CONSTRUCTION DOCUMENTS CHICK-FIL-A POWERS & PALMER

CDs for public improvements only

Merrick comment response
noted in blue text box with
white background

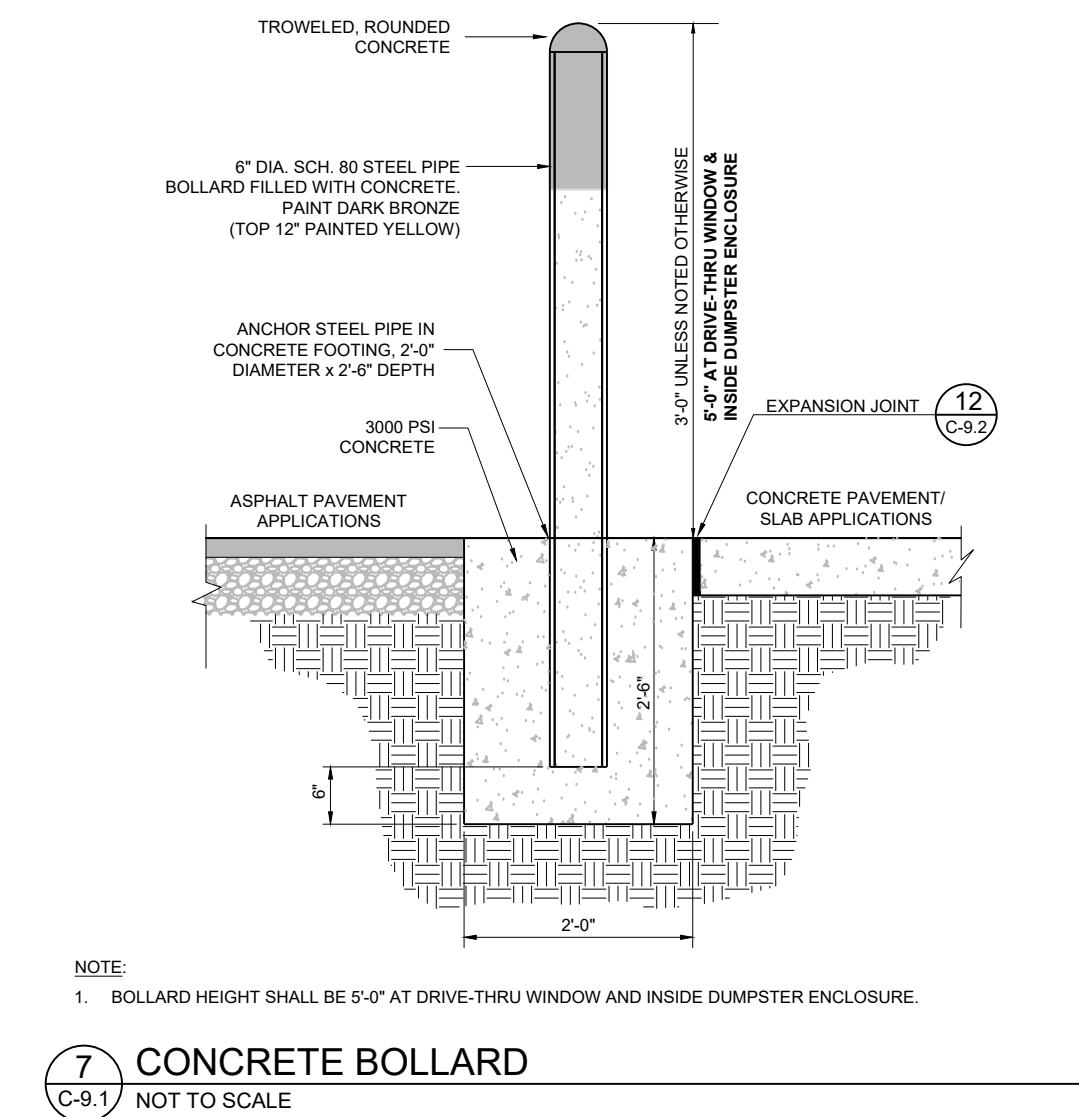
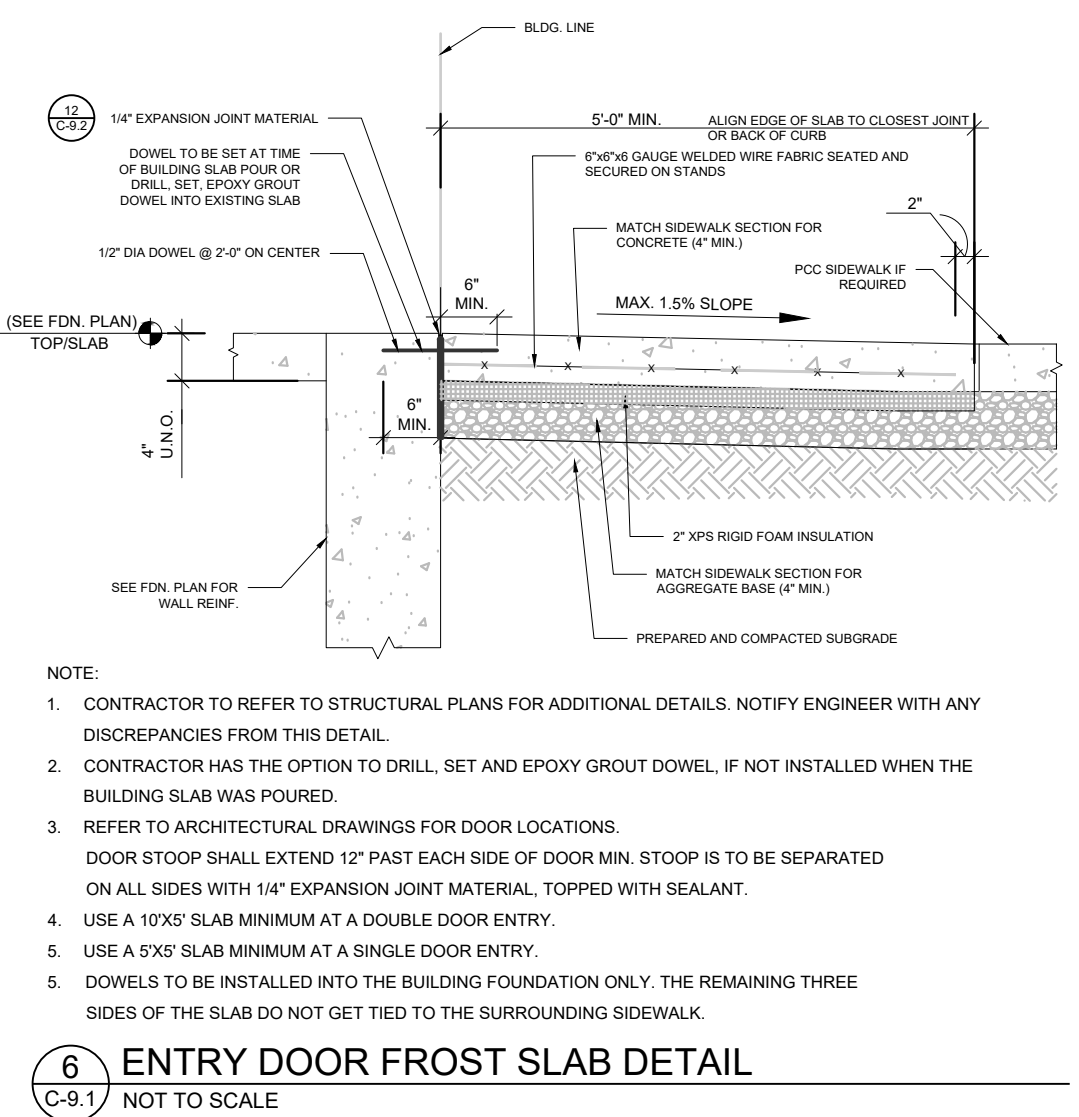
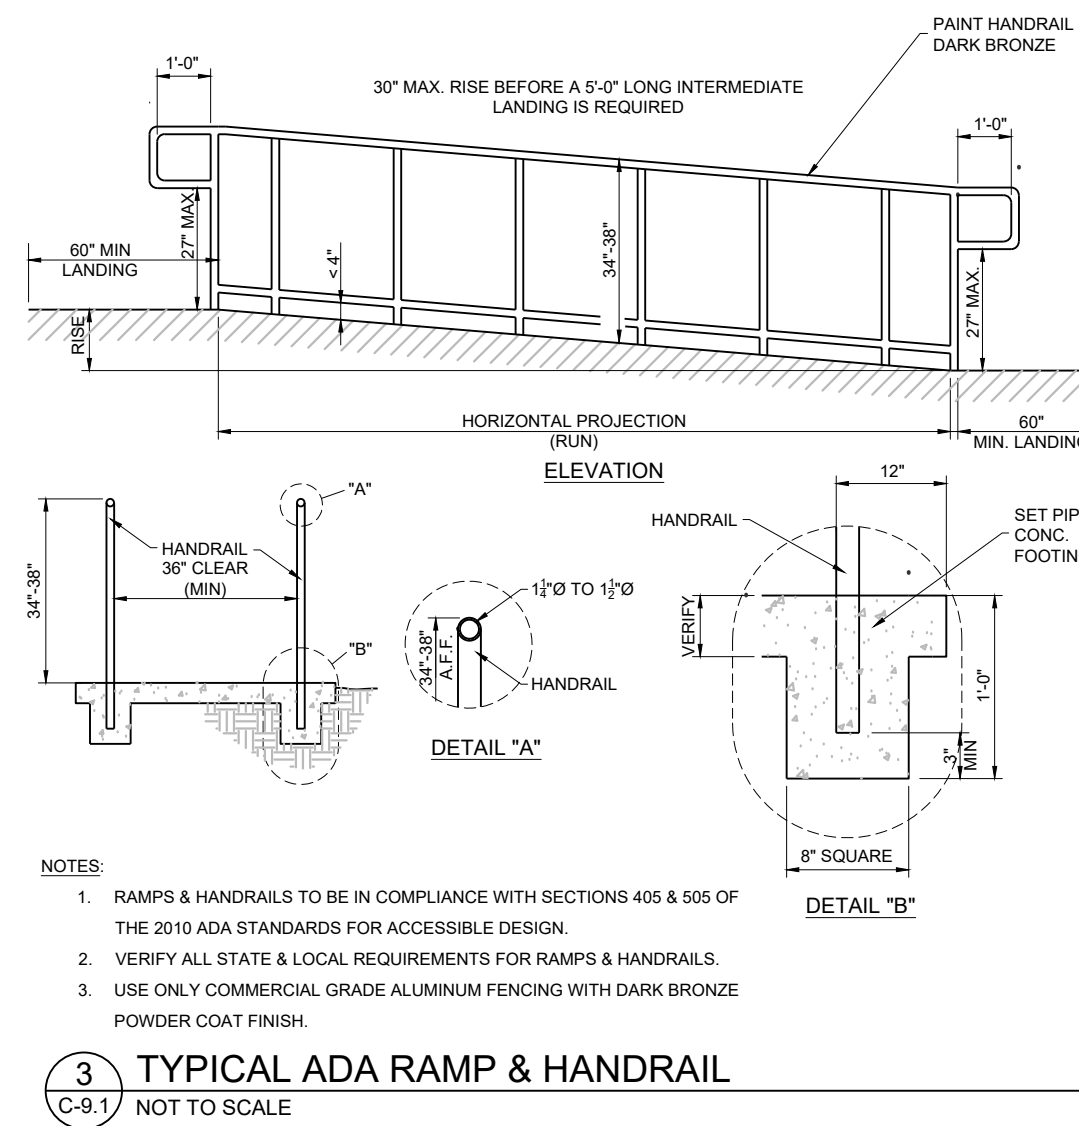
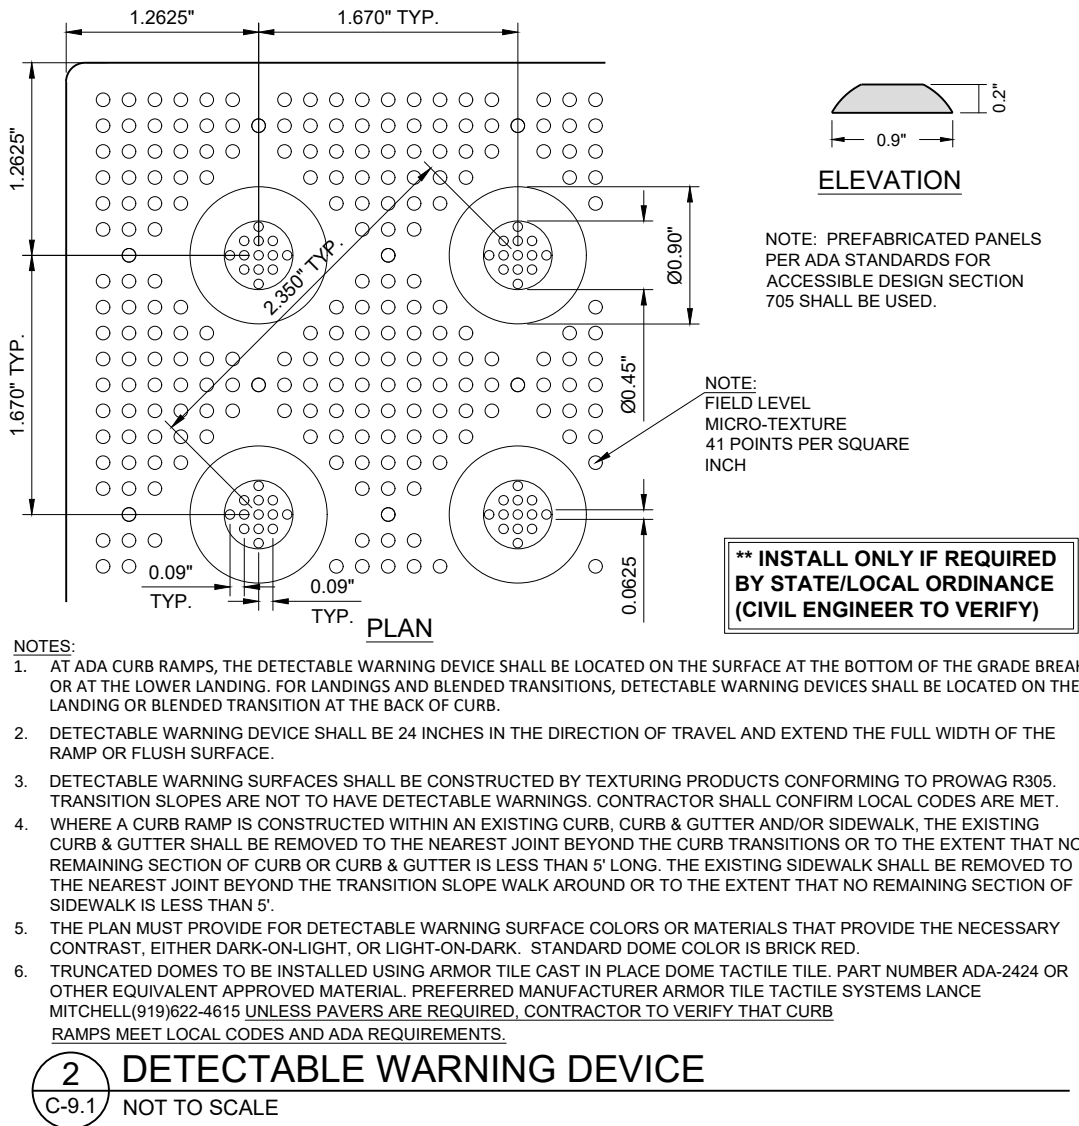
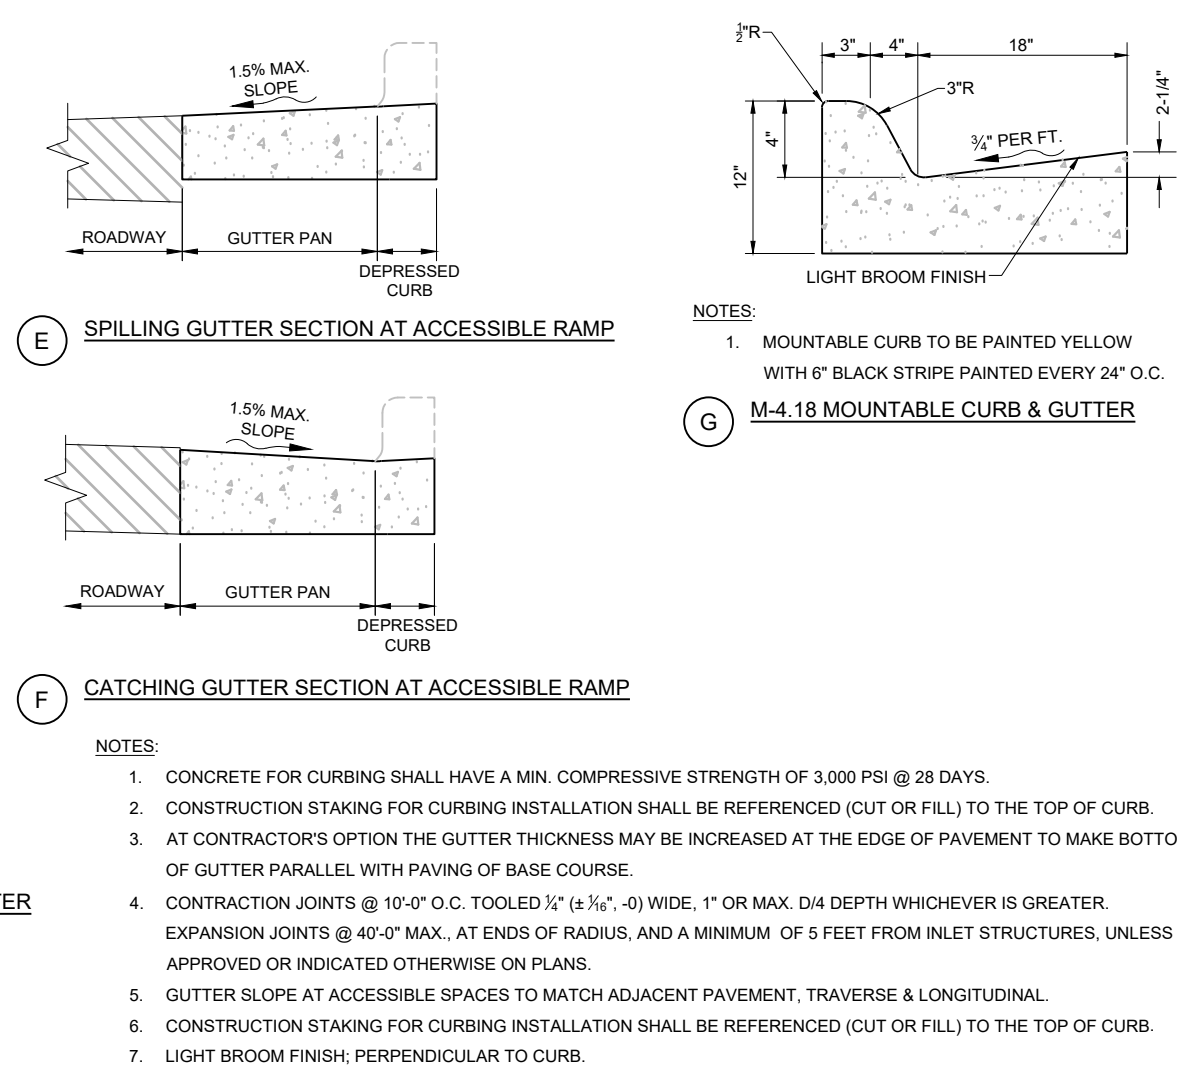
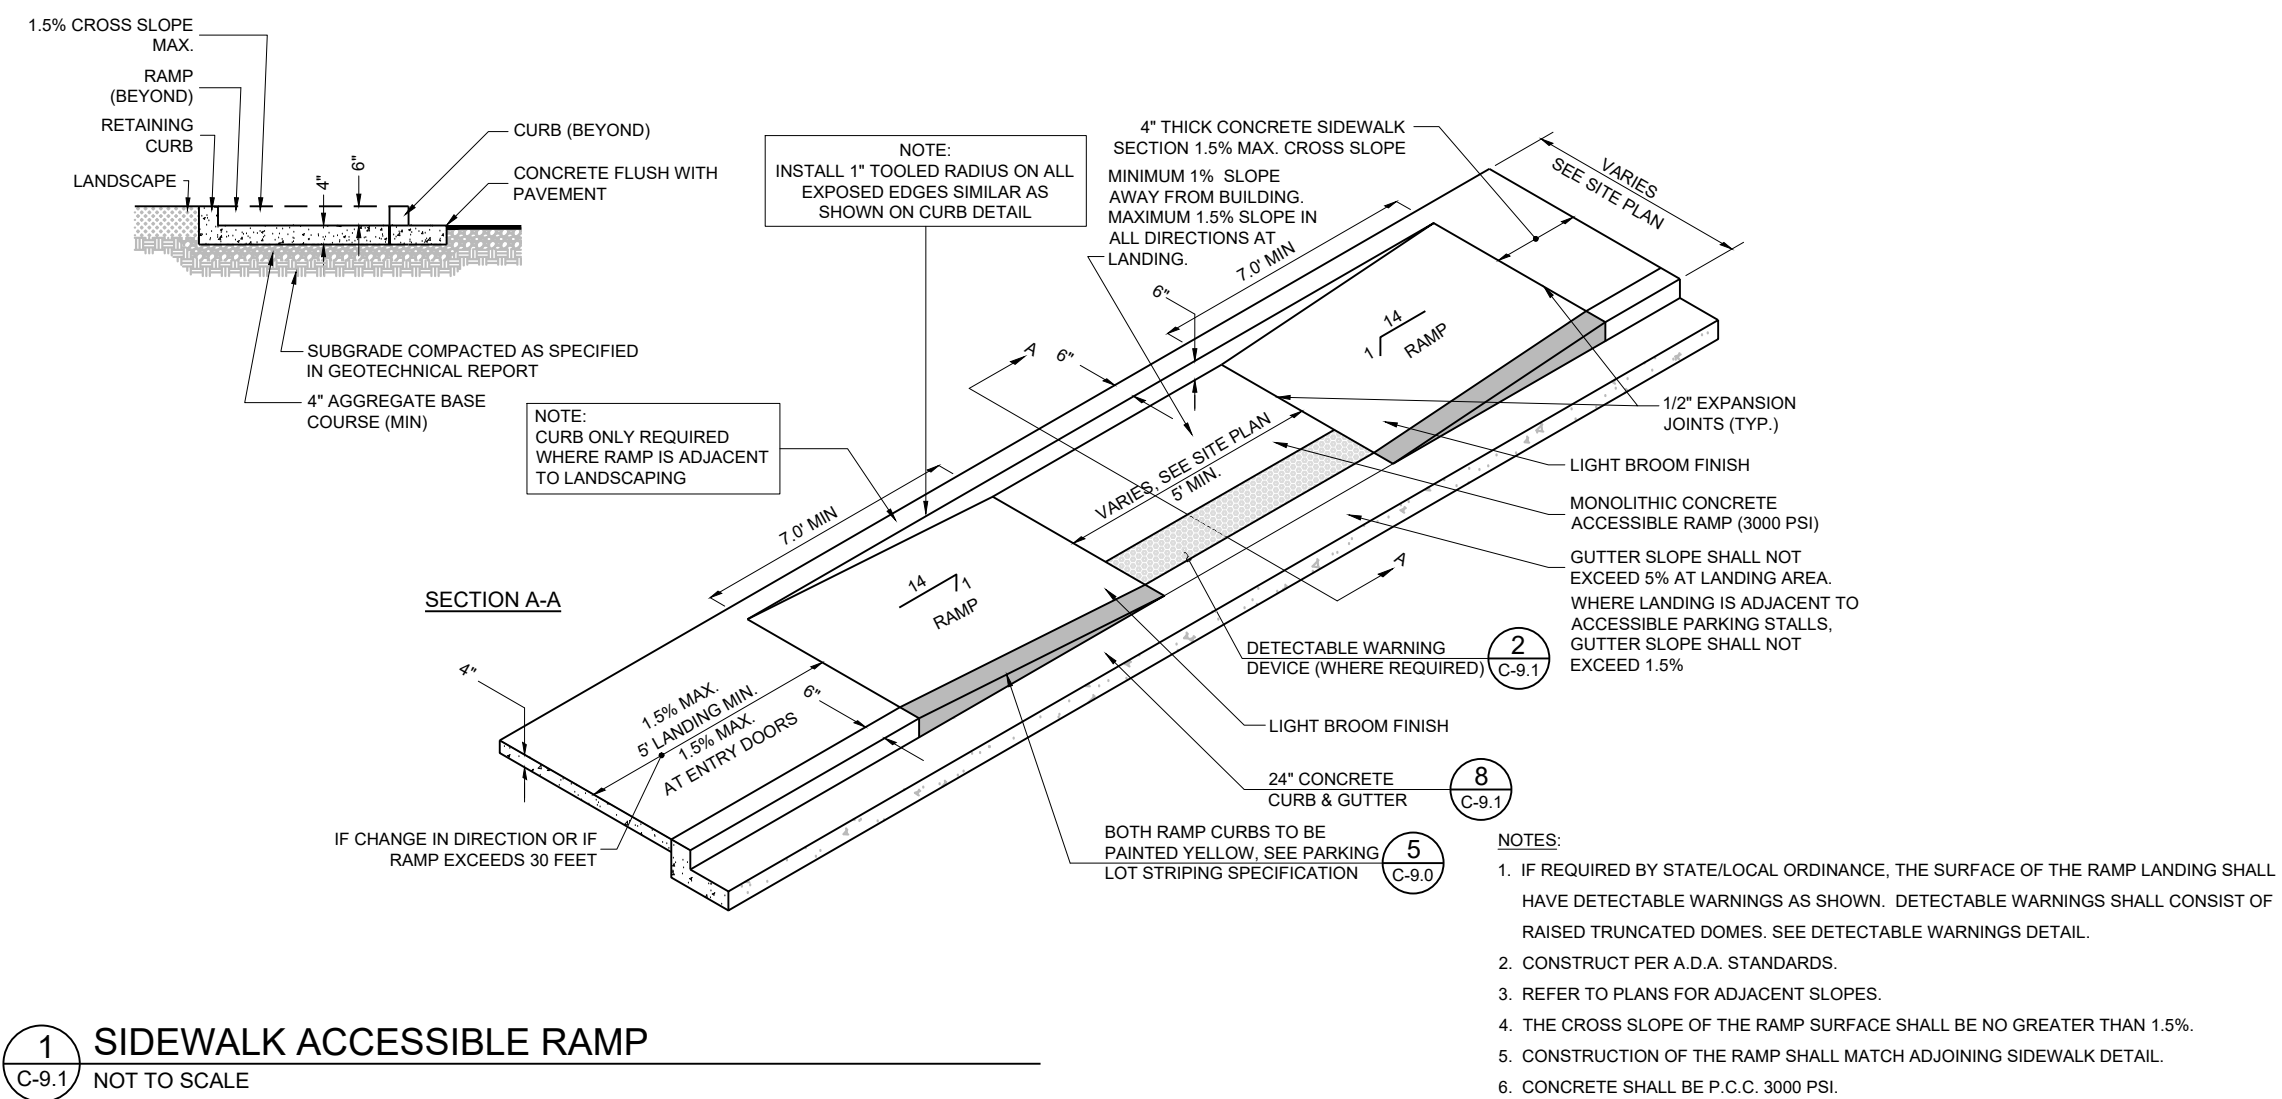
place with SDP sheet set

Added to SDP Plan Set
